Blaine House & Parking Garage Driveway Reconstruction Project

Addendum No. 1

September 2, 2015

PROPOSED J-BX & CONDUIT RUNS
NOT TO SCALE

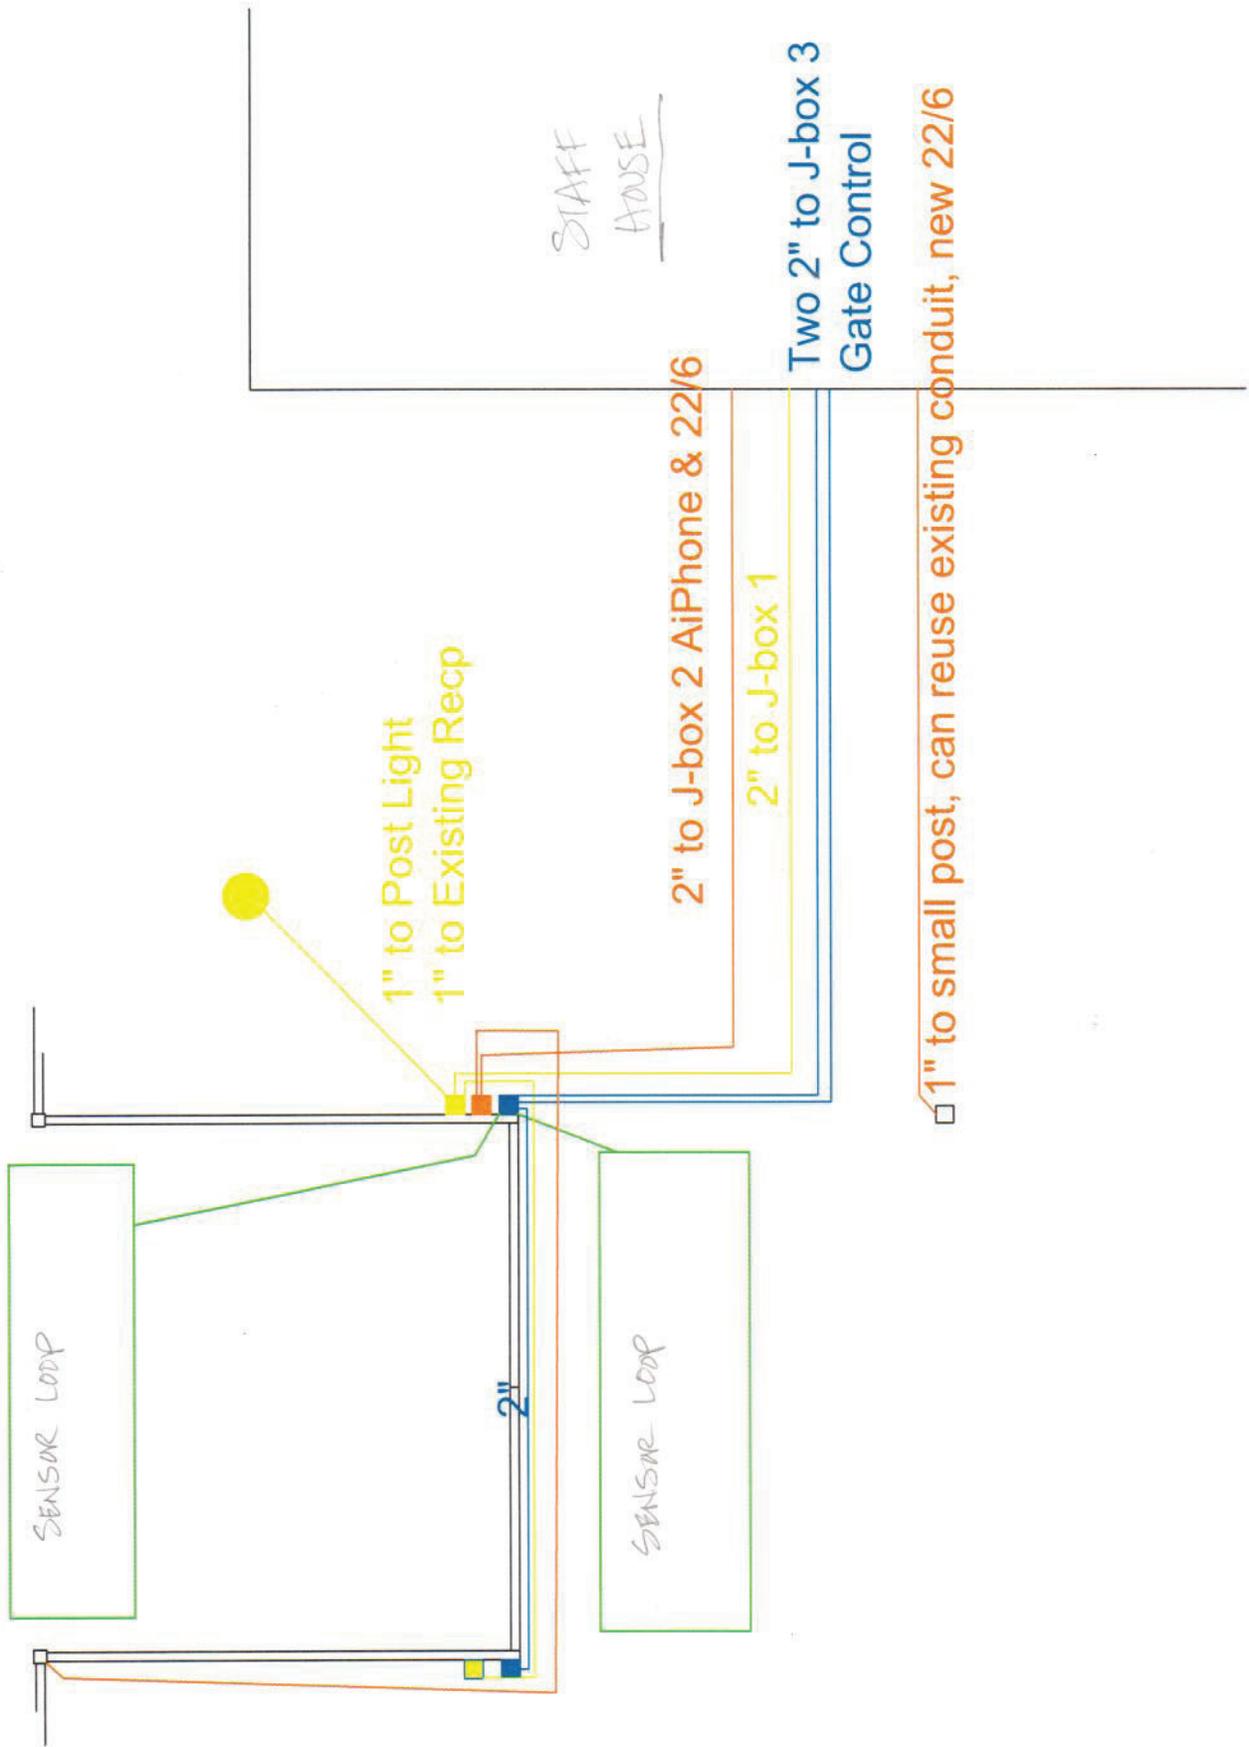
1. Location of Owner Required Utility Trench & Gate Sensor Loops: ADD scope of work to Contract Documents. Owner will not be performing the installation of the conduits, cables, or gate operator system.
2. ADD Reference sketch showing Proposed J-box & Conduit Runs.
